Product/Process Change Notice (PCN)

PCN #: PCN_WE-STAR-
TEC_20150731_742711xx(S)_Packing-Change

Product Affected: 74271111(S), 74271112(S),
74271131(S), 74271132

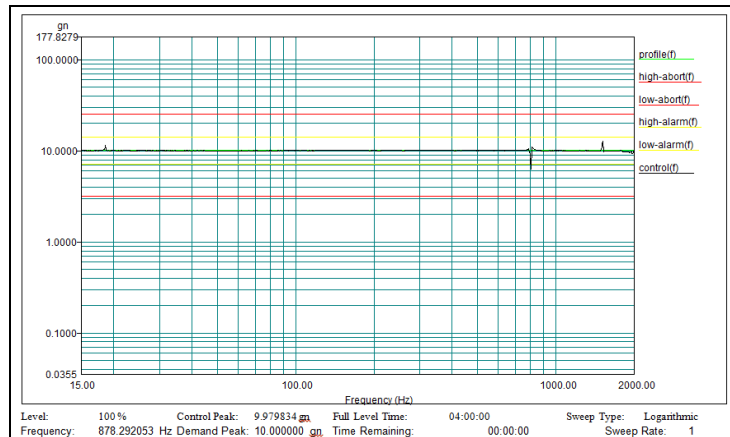
Due to size and design change of the tray, the packing size and packing quantity will change as detailed in the tables below. Carton box material will remain double wall corrugated cardboard.

PN: 74271111(S), 74271112(S), 74271131(S), 74271132		New Packaging	Old Packaging
Standard Packaging Quantity (SPQ)	pcs	190	180
Quantity of a full tray	pcs	38	20
Number of trays	pcs	5	9
Moisture Impermeable Bag (MIB)	pcs	yes	yes
Dimensions of the carton (LxWxH)	mm	385 x 305 x 135	335 x 230 x 180
Dimensions of a tray (LxWxH)	mm	370 x 280 x 12	315 x 215 x 3
Weight of a SPQ	g	7500	6560
Weight of a full tray	g	1400	700
